Product/Process Change Notice (PCN)

PCN_IndTIS_20130826_packaging_COt.doc

Product Affected: WE-TIS

Before improvement:

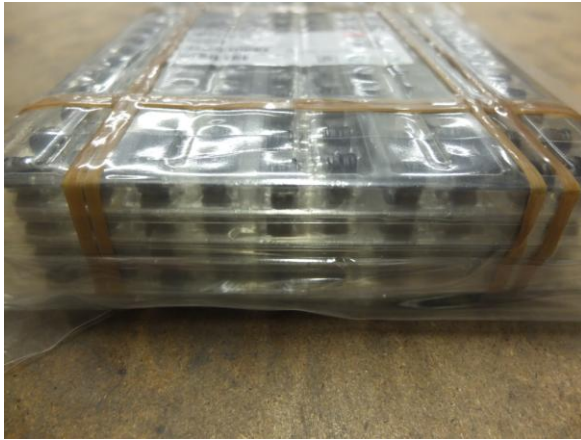
Each tray is fixed with an adhesive tape.

5 Trays were fixed with an adhesive tape and packed into a vacuum bag.

Each tray is fixed with an adhesive tape
5 Trays were fixed with rubber bands and packed into a vacuum bag.
